DART SERVICE INSTRUCTION

TO AMEND INSTALLATION INSTRUCTIONS IIN-D350-689 REV. B AND INSTRUCTIONS FOR CONTINUED AIRWORTHINESS ICA-D350-689 REV. 1

REF. TCCA STC: SH02-33
REF. FAA STC: SR01620NY
REF. EASA STC: EASA.IM.R.S.01453
REF. TCA STC: 2005S03-09

1.0 PURPOSE

FIGURE 1: UPDATES TO CROSS SECTIONS F-F AND M-M
 With reference to Figures 5 and 7 of IIN-D350-689
 (Figures 25-5 and 25-7 of ICA-D350-689)

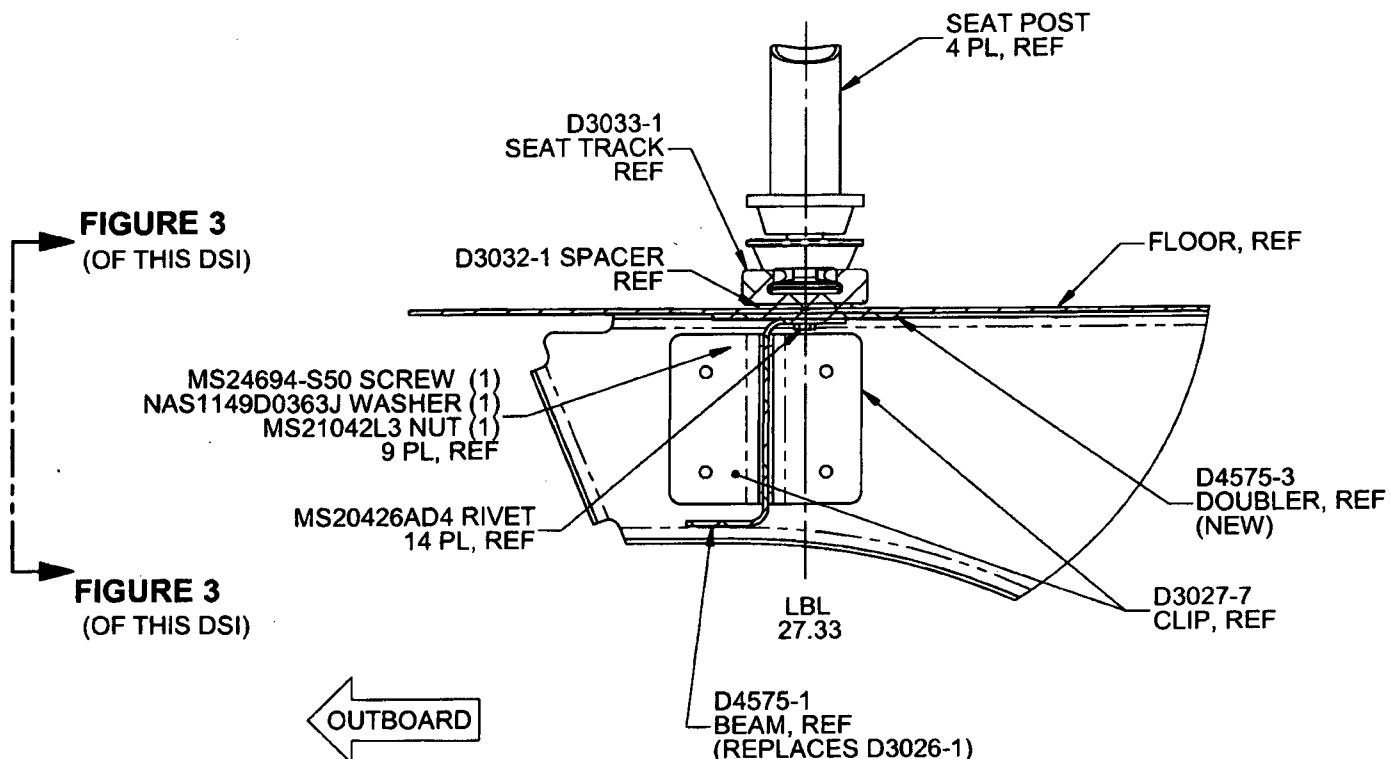
For D350-689-011/-013 at CHG 006/005 and later and D350-689-021/-023 Kits at CHG 005/004 and later, the D3026-1 Channel has been replaced with the D4575-1 Beam and D4575-3 Doubler and the D3234-3 Doubler has been removed. Consequently, the installation instructions for D350-689-011/-013 at CHG 006/005 and D350-689-021/-023 at CHG 005/004 are updated per Section 2.0 of this Service Instruction. The parts list update is shown in Section 4.0 of this Service Instruction. There is a negligible change to the weight and balance.

If there is an existing stringer at LBL 27.33, it will need to be removed from that location. Locate D4575-1 Beam, D4575-3 Doubler, and D3032-1 Spacer as shown in Figure 1 of this Service Instruction. Transfer drill existing holes from the aircraft floor to the D4575-1 Beam, D4575-3 Doubler, and D3032-1 Spacer. Ensure 1.0" to 1.5" rivet pitch and add additional holes if required. If there is no existing stringer, locate D4575-1 Beam, D4575-3 Doubler, and D3032-1 Spacer as shown in Figure 1 of this Service Instruction and drill Ø0.128" holes on a 1.0" to 1.5" pitch.

If there is an existing stringer at LBL 27.33, it will need to be removed from that location. Locate D4575-1 Beam and D4575-3 Doubler as shown in Figure 2 of this Service Instruction. Transfer drill existing holes from the aircraft floor to the D4575-1 Beam and D4575-3 Doubler. Ensure 1.0" to 1.5" rivet pitch and add additional holes if required. If there is no existing stringer, locate D4575-1 Beam and D4575-3 Doubler as shown in Figure 1 of this Service Instruction and drill Ø0.128" holes on a 1.0" to 1.5" pitch.

FIGURE 3: RELIEFS ON D4575-1/-3
(ONLY D4575-1/-3 SHOWN FOR CLARITY)
VIEW LOOKING INBOARD

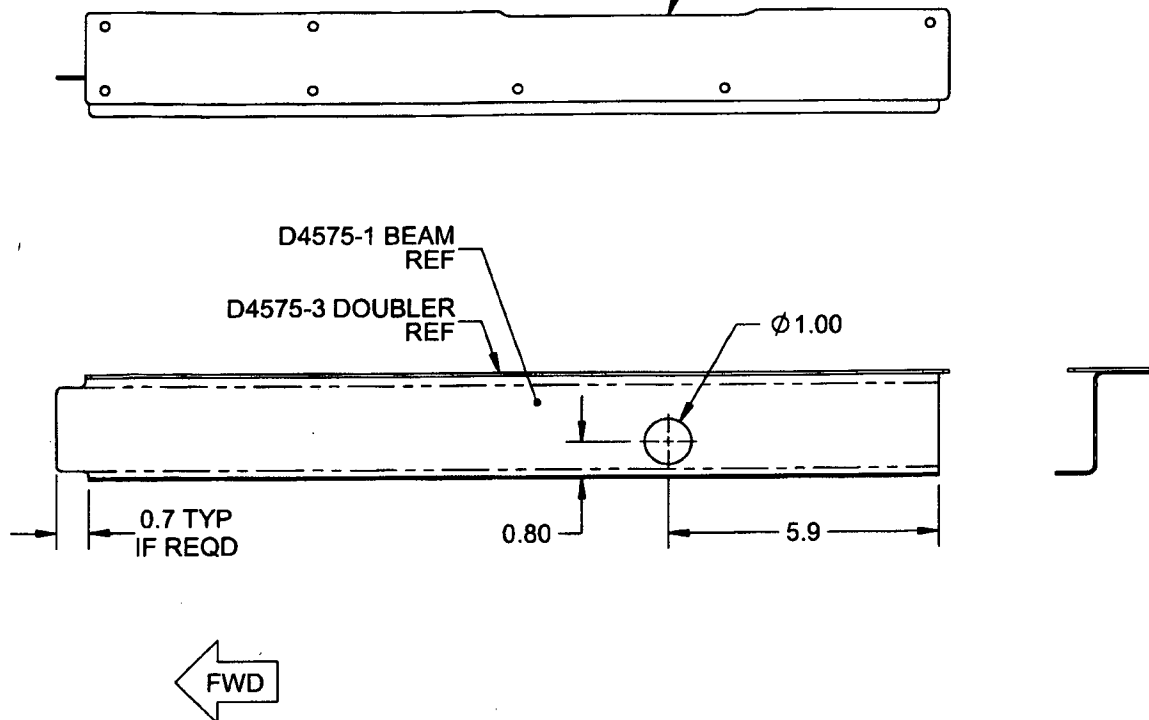
Note: Drill a Ø1.00" (Ø25.4 mm) hole in the D4575-1 Beam to clear extension tube of collective and cutout as required for clearance of collective opening and fwd bulkhead as shown in Figure 3 of this Service Instruction.

Note: Drill a Ø1.00" (Ø25.4 mm) hole in the D4575-1 Beam to clear extension tube of collective and cutout as required for clearance of collective opening and fwd bulkhead as shown in Figure 3 of this Service Instruction.

TRANSFER EXISTING CUTOUT
FROM AIRCRAFT FLOOR A/R TO
D4575-1/-3 FOR COLLECTIVE OPENING
